MEMORANDUM

Subject: SPCC Inspection: Sybill Inc.
Detroit, Wayne County, Michigan
TDD # T05-~~4~~201-017
PAN # EMI1282CAA

A SPEC INSPECTION FIELD SHEET

C. DETAILED SPCC DOCUMENTATION		SEE INSTRUCTIONS ON PAGE 1
FACILITY	Sybill Inc.	DATE OF INSPECTION 1/13/92
1. FACILITY DESCRIPTION		
1A. TYPE OF BUSINESS/OPERATION	WASTE OIL TREATMENT AND RECOVERY	
1B. FACILITY OIL STORAGE	2 - 250,000 gal LEAVING/STORAGE TANKS 2 - 360,000 gal TREATMENT/STORAGE TANKS 1 - 176,000 gal TREATMENT/STORAGE TANK	
1C. PREVENTION MEASURES PROVIDED		
① DIRMING AROUND ALL TANKS CAPABLE OF CONTAINING LARGEST TANK VOLUMES WITHIN DIKE. ② 24 hr guard service on site, Emergency Phone #'s easily viewed ③ Spill Clean up contractor - NAVE Inc. 3345 Greenfield, Newindale EPA # 005356787, 24 hr phone 313 925 6300 ④ LOADING AND UNLOADING Supervised and performed with in Aggregate containment.		
1D. APPEARANCE OF FACILITY (ANSWER IN)		
Very clean. Areas within containment are smooth CONCRETE ARE EASY CLEAN UP. NO UNUSED DRUMS OR DEBRIS FOUND ON SITE. ALL ON SITE DRAINS ARE PLUGGED.		
1E. PAST SPILL HISTORY

TITLE	Site Location	FIGURE #
SITE	Sybill Inc.	SCALE
SOURCE/DATE	January 17, 1992	1 = 24,000
USGS 7.5 Minute Series (Topographic) Quadrangle	CITY Detroit	STATE Michigan
		TDC # T059201-017

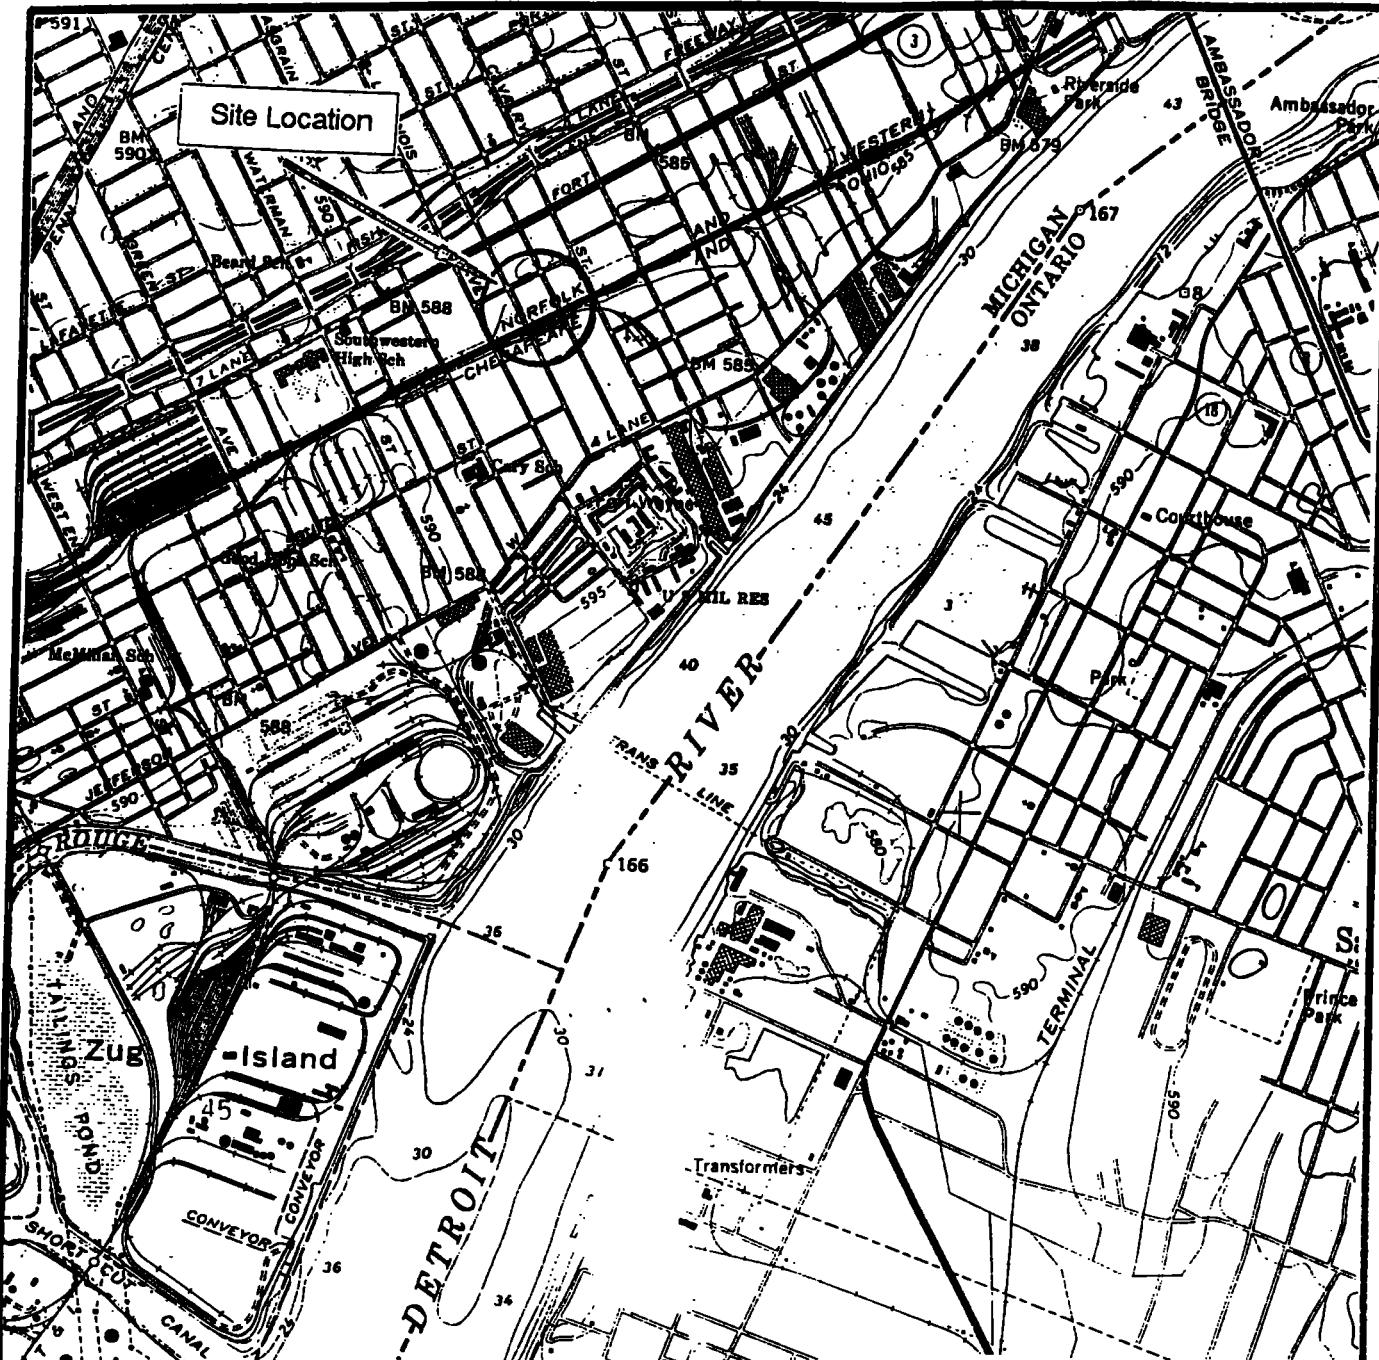
DETROIT RIVER. Flows from NORTHEAST to SOUTH of THE SITE. IT IS LOCATED .65 miles from THE SITE AND FLOWS SOUTH AT 6 miles/hr into lake ERIE. (Figure 1)

IF CONTAINMENT WERE TO RUPTURE the QUICKEST PATH TO THE RIVER WOULD BE THROUGH STORM SEWERS OR OVERLAND.
